APPENDIX M

*DRAFT EIS COMMENTS AND RESPONSES
TO COMMENTS*

This appendix contains a list of 332 substantive comment submissions received concerning the Draft Environmental Impact Statement (EIS) during the 67-day comment period (August 21, 2020 through October 27, 2020) and the responses to those comments.

EXHIBIT M.4-1
CLOSEST RESIDENTIAL USES TO PROPOSED PROJECT SITE

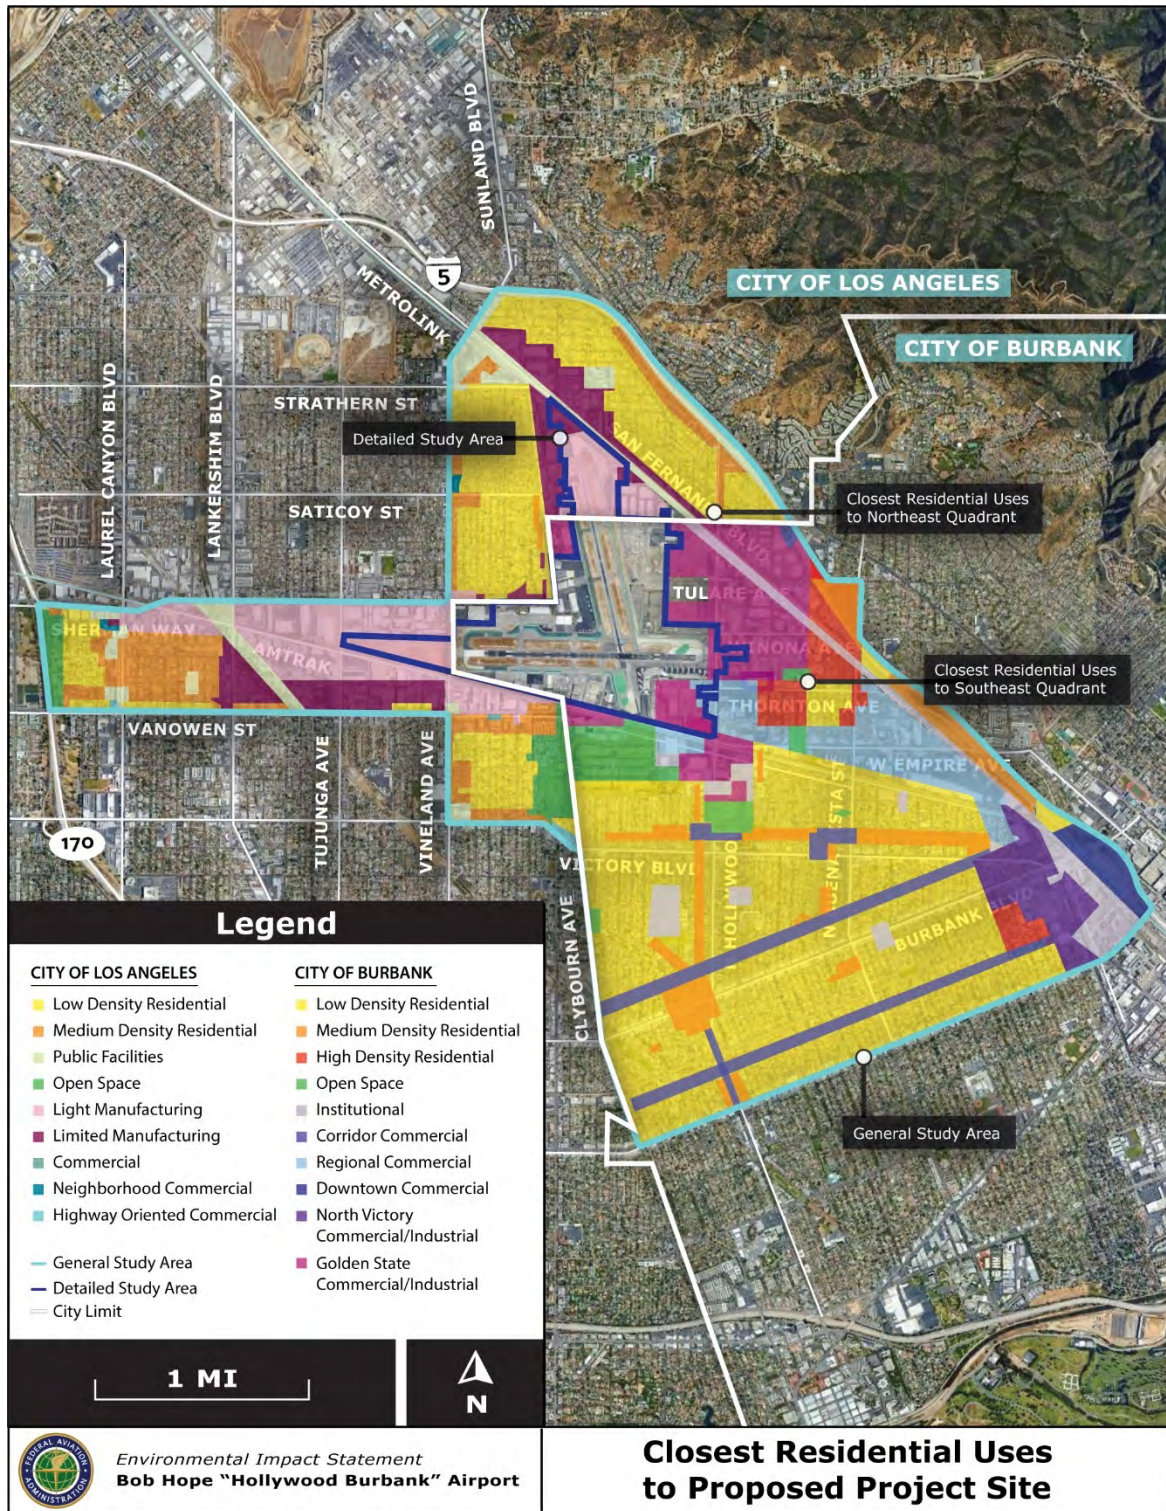
28. The comment stating that the EIS does not include maps or graphics showing noise sensitive sites is not correct. **Exhibits 3.10-1, 3.12-1, 4.11-1 and 4.11-2** of the EIS, all show existing land uses in the General Study Area, including residential areas in relation to the Proposed Project site. **Exhibits 3.7-1, 3.9-2, and 4.6-1** show other noise sensitive sites such as Section 4(f) properties and historic properties. **Exhibit M.4-1** shows the locations of the closest residences to the Airport. The comment's footnote states that the EIR, prepared in compliance with CEQA (by the Authority [not FAA]), reported the closest residence from the Proposed Project site was 740 feet northeast of the Proposed Project site while the EIS reports the closest residence is 830 feet northeast from the Proposed Project site, a difference of 90 feet. Depending on where on the starting measurement on the Proposed Project site was taken (i.e., from the boundary of the Airport or from the closest location on Airport where aircraft would be operating), the margin of error is well within the 90 feet difference pointed out in the comment. Nonetheless, the Proposed Project does not result in a significant noise impact, which is defined by FAA Order 1050.1F³⁹ as being an increase in *"noise by DNL 1.5 dB or more for a noise sensitive area that is experiencing noise at or above the DNL 65 dB noise exposure level, or that will be exposed at or above the DNL 65dB level due to a DNL 1.5dB or greater increase, when compared to the no action alternative for the same timeframe"* or other impacts that could affect residential areas northeast of the Proposed Project.
